ADDENDUM NO. 1 TO CONTRACT DOCUMENTS

Date: May 20, 2025
Project: Utley Creek WRF - Lab & Operators Building
Owner: Town of Holly Springs
Engineer: Hazen and Sawyer

Addendum No.1

STOREFRONT TYPES

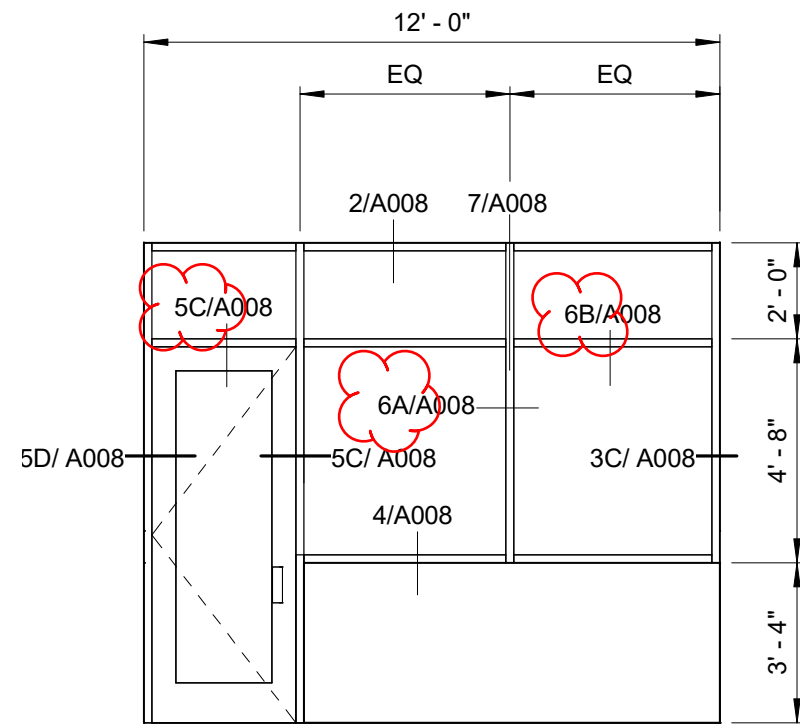
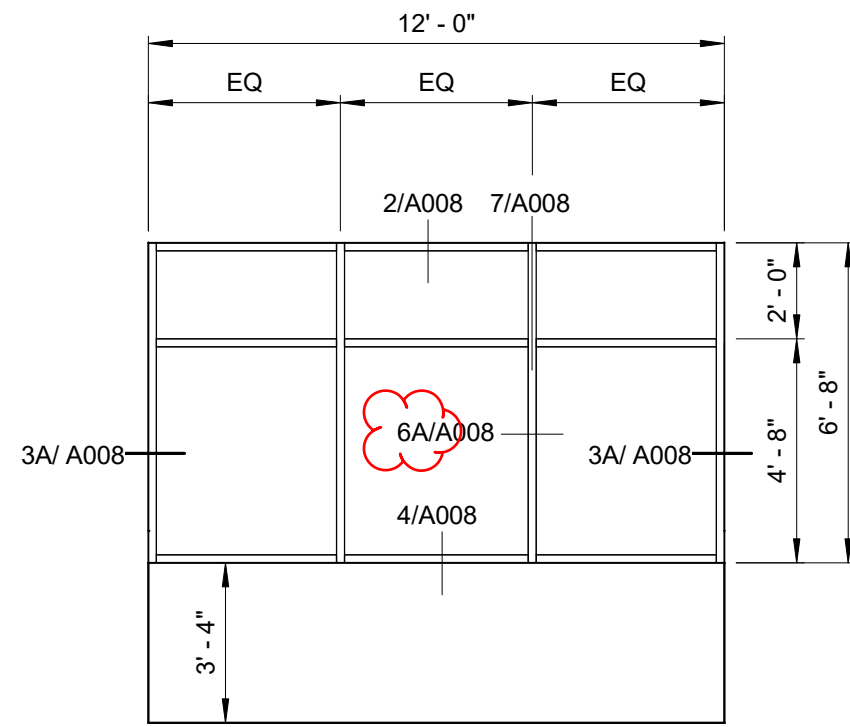
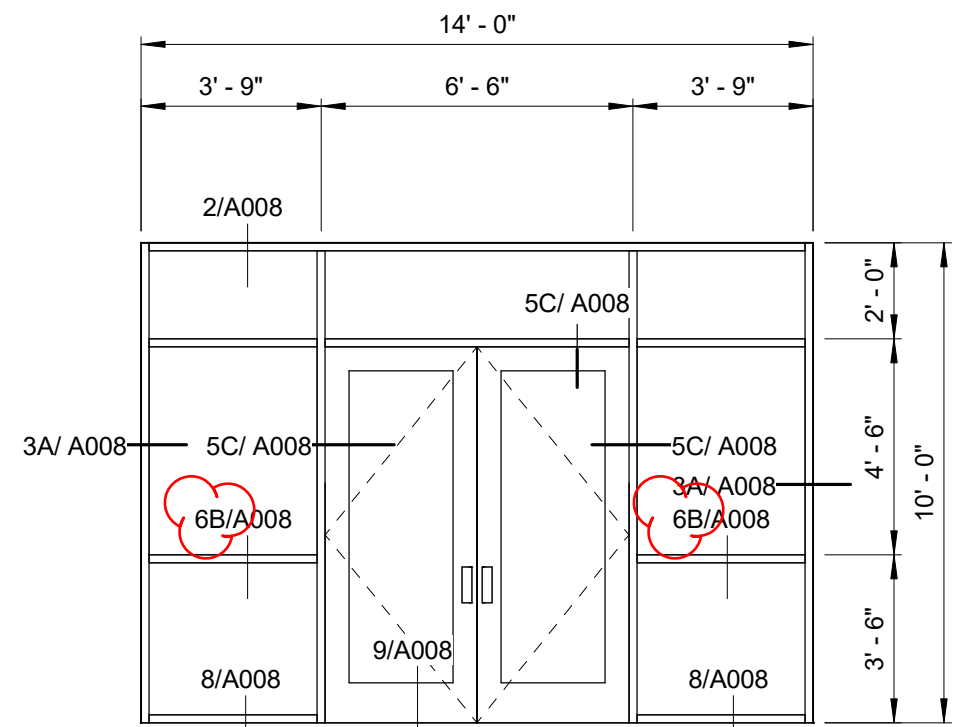
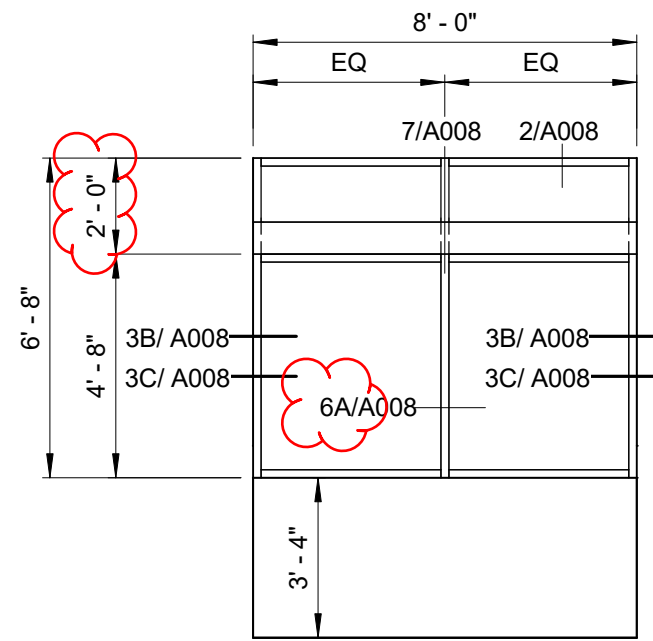
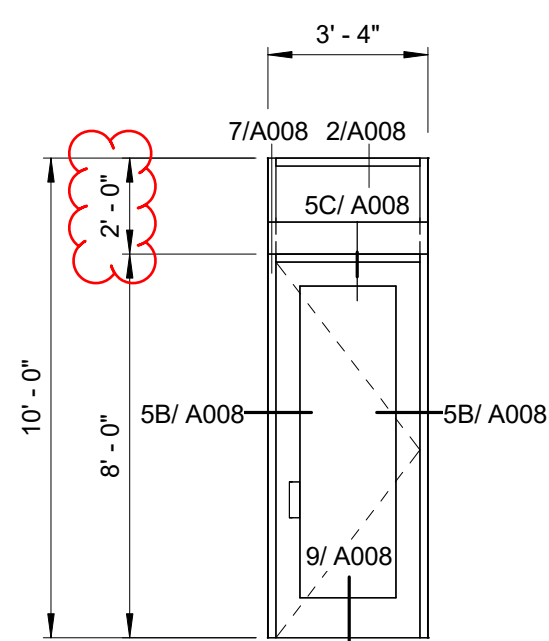
- A004 Replace Room Finish Schedule with table provided in **Attachment #3**.
- A005 Revise Door Schedule with table provided in **Attachment #4**.
- A007 Replace STOREFRONT TYPES. SF-1, SF-2, SF-6, SF-7, SF-8 with details in **Attachment #5**.
- Replace SF-3, SF-4, SF-5, SF-9, SF-10 with details in **Attachment #6**.
- A008 Detail 6A:
 Delete the word 'HORIZONTAL' and replace with 'VERTICAL'.
- Detail 6B:
 Delete the word 'VERTICAL' and replace with 'HORIZONTAL'
- Replace SUNSHADE SUPPORT Detail 7 with **Attachment #7**.
- A805 Add dimensions to roof screens as depicted in **Attachment #8**.

ATTACHMENT NO.
9

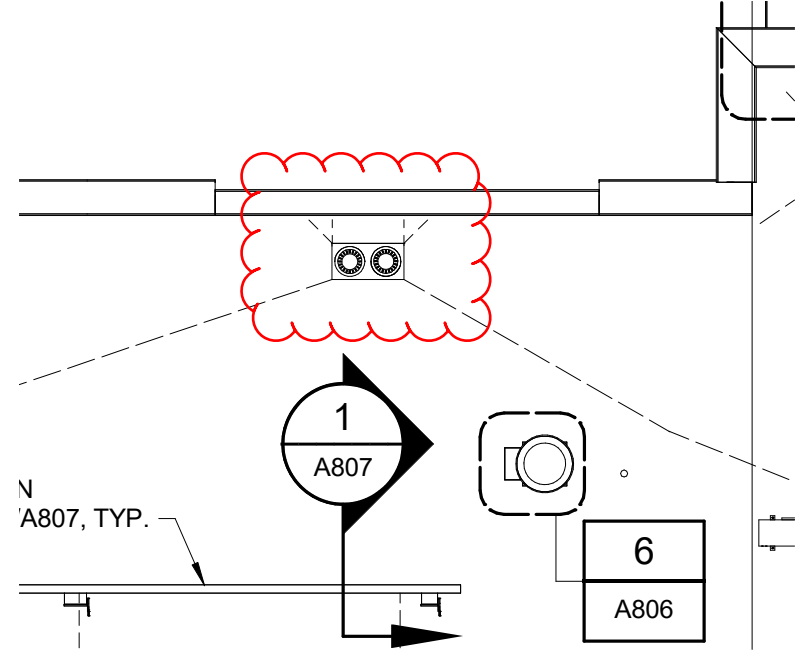
Delete extra roof drain as depicted in **Attachment #9**.

ADDENDUM NO. 1	DATE 5/16/2025	TOWN OF HOLLY SPRINGS HOLLY SPRINGS, NORTH CAROLINA	HAZEN JOB NUMBER 31407-006	REFER TO CONTRACT DRAWING NUMBER A819
ATTACHMENT NO. 10	BY DW	UTLEY CREEK WRF LAB & OPERATORS BUILDING	CONTRACT NUMBER --	SHEET 1 OF 2

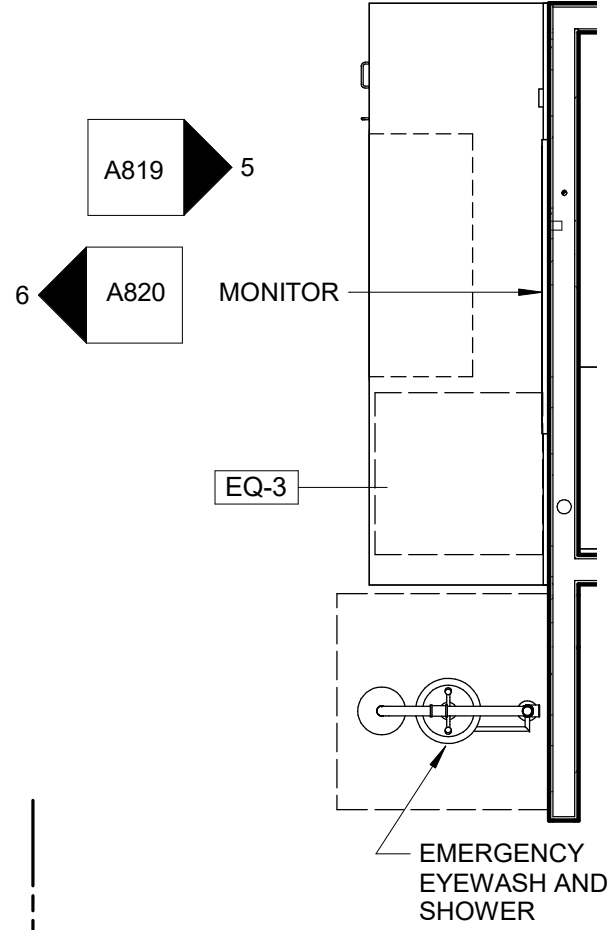
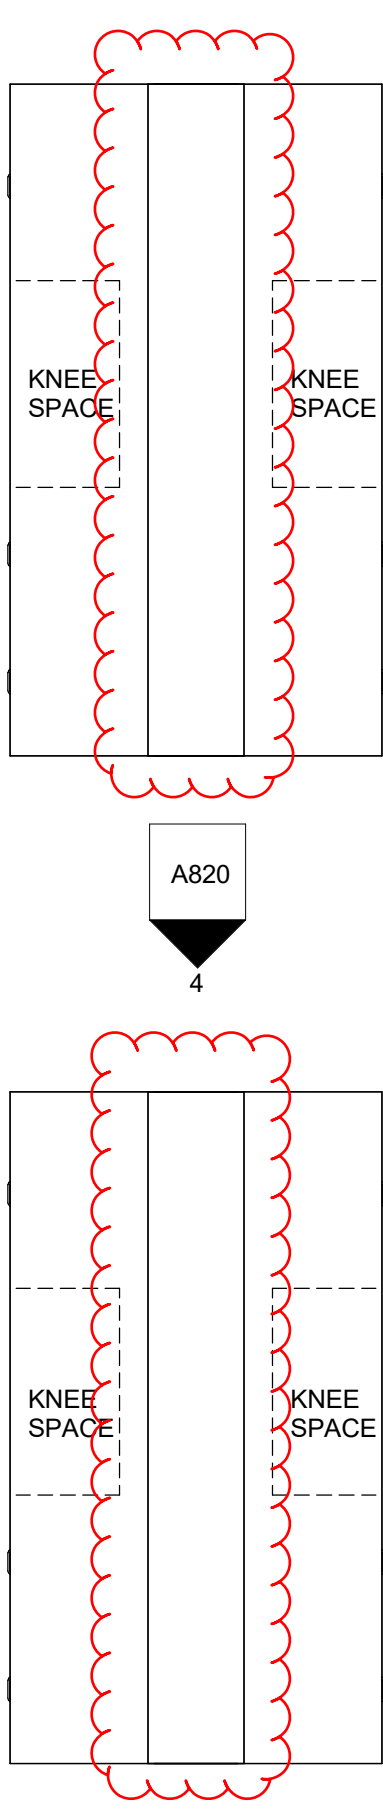
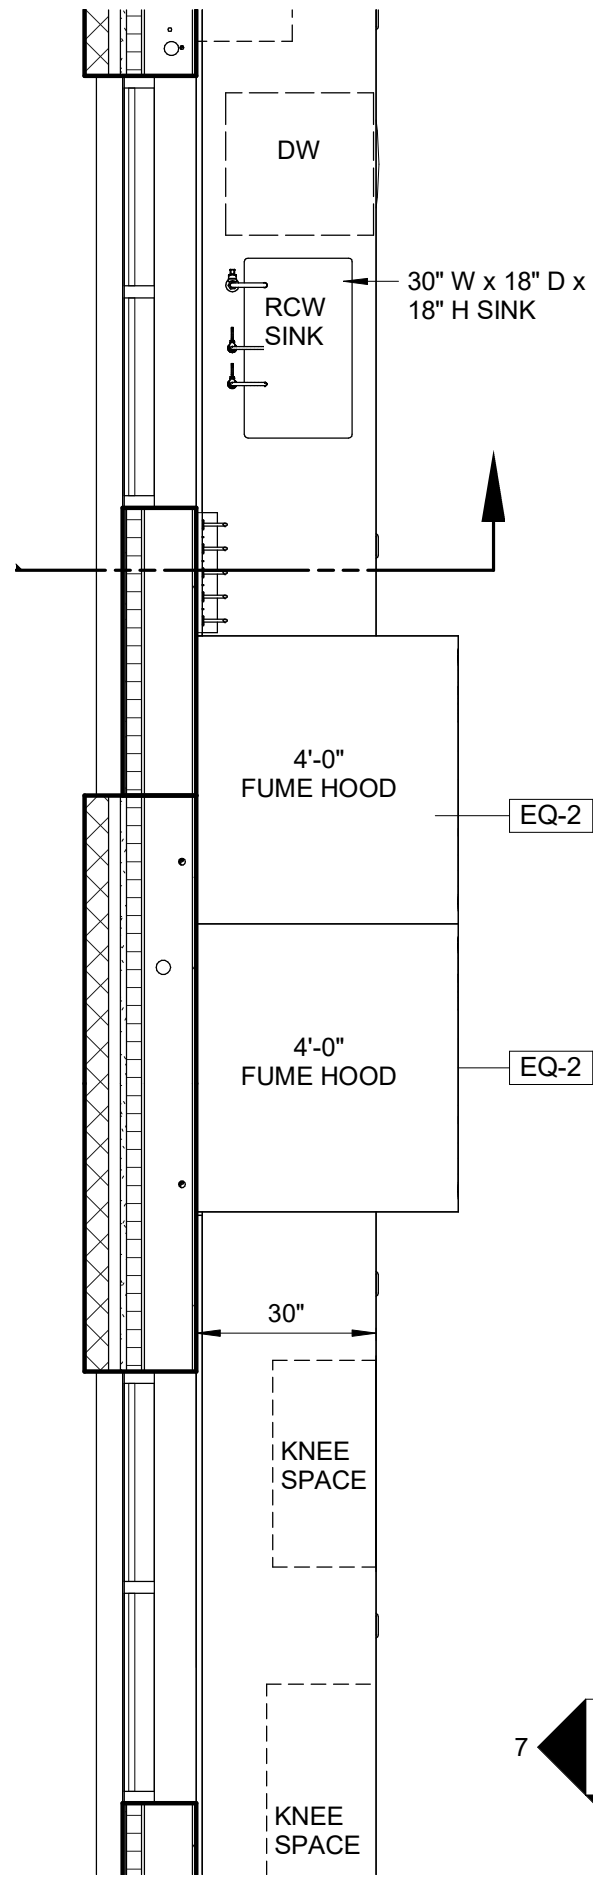
A819 ENLARGED LAB PLAN: Add raised panel to lab islands as depicted in **Attachment #10**.

LABORATORY ISLAND

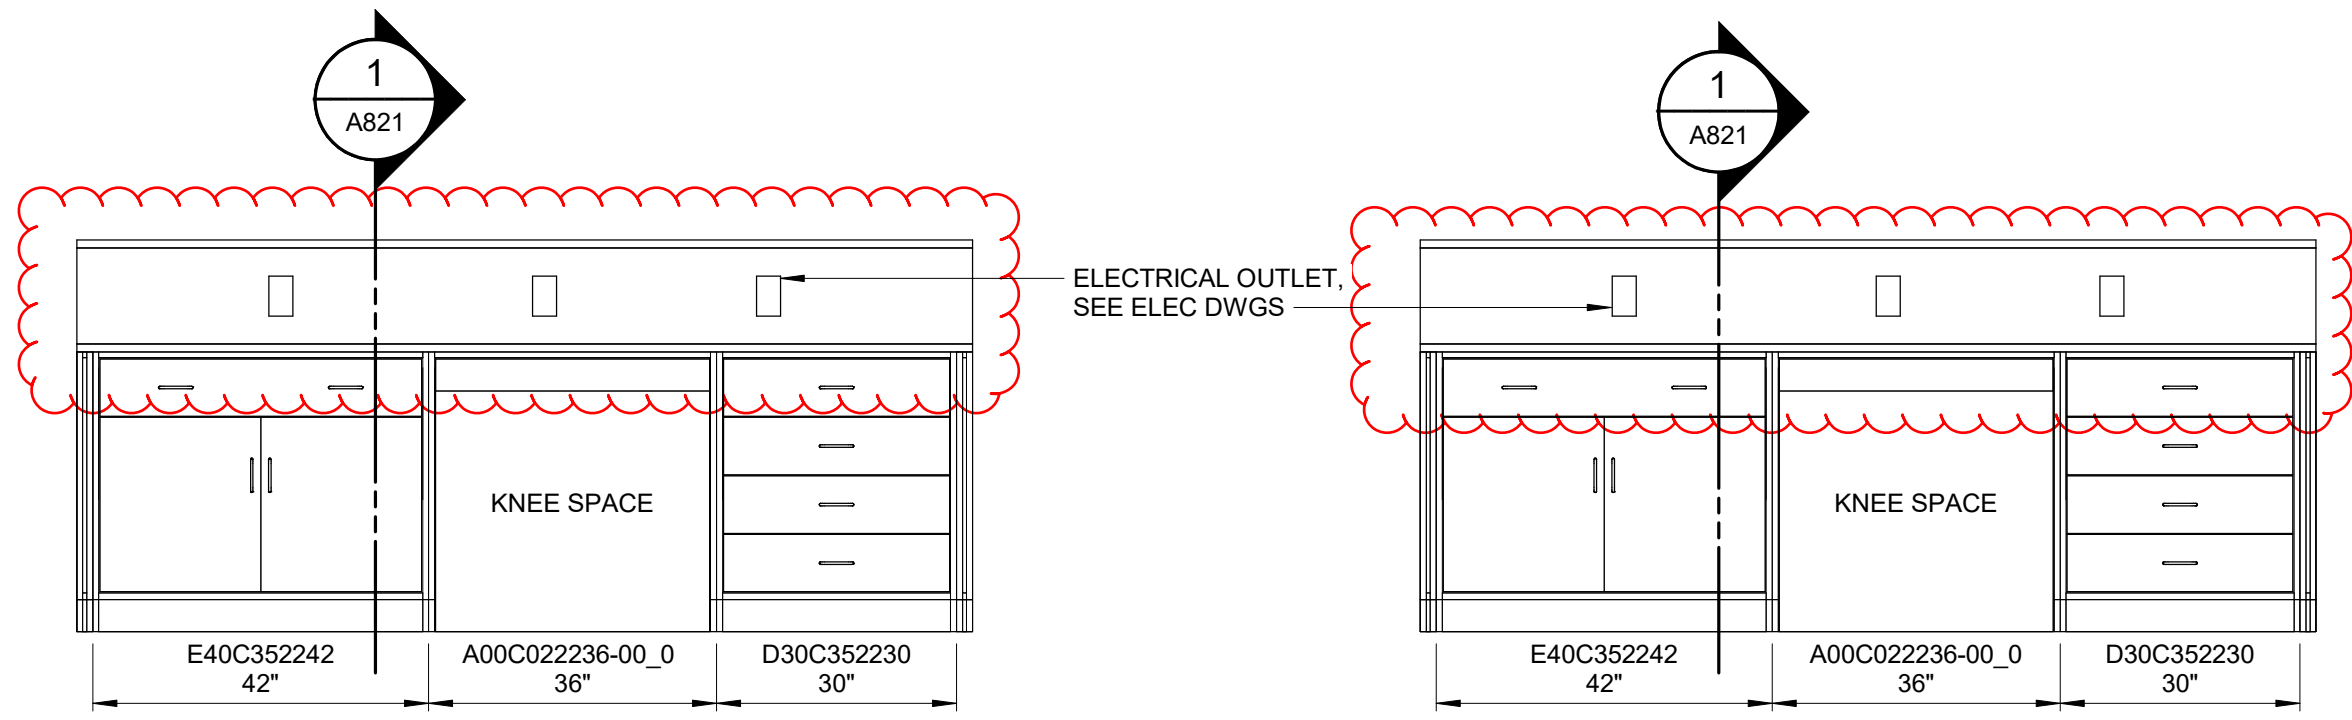
Detail 6, LABORATORY ISLAND: Add raised panel to lab island as depicted in **Attachment #11**.

ISLAND END

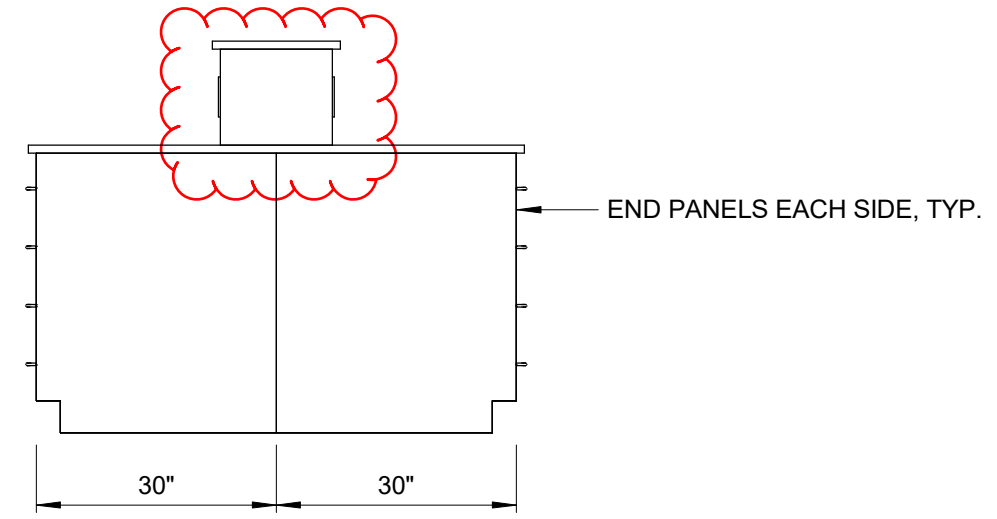
A820 Detail 4, ISLAND END: Add raised panel and electrical outlets to lab islands as depicted in **Attachment #11**.

LAB ISLAND CABINET SECTION

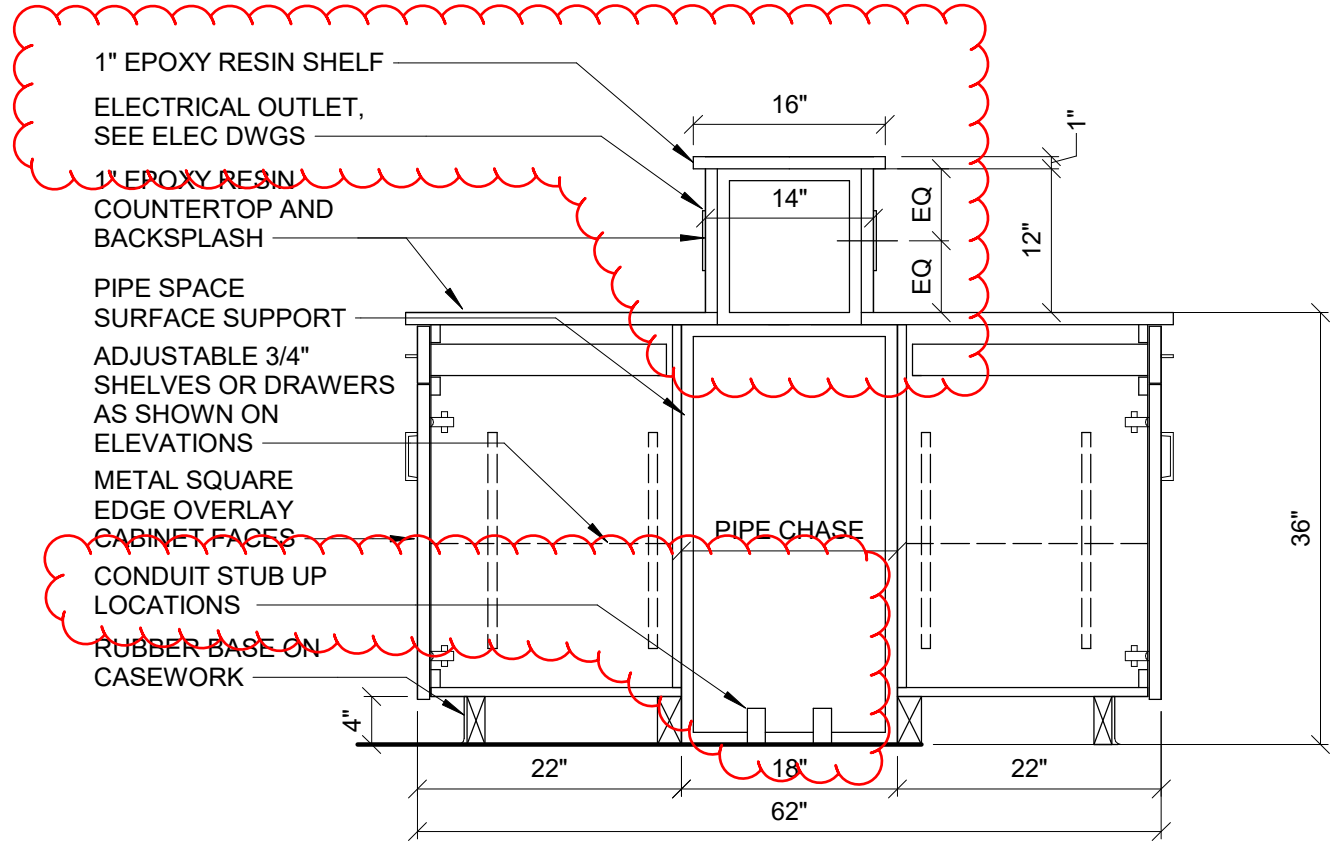
A821 Detail 1, LAB CABINET SECTION: Revise Detail to include raised panel and outlets as depicted in **Attachment #12**.

"7. Reference Architectural detail 1/A820 for island receptacle mounting heights and approximate conduit stub up locations. Exact conduit stub up locations shall be coordinated with the island millwork manufacturer."
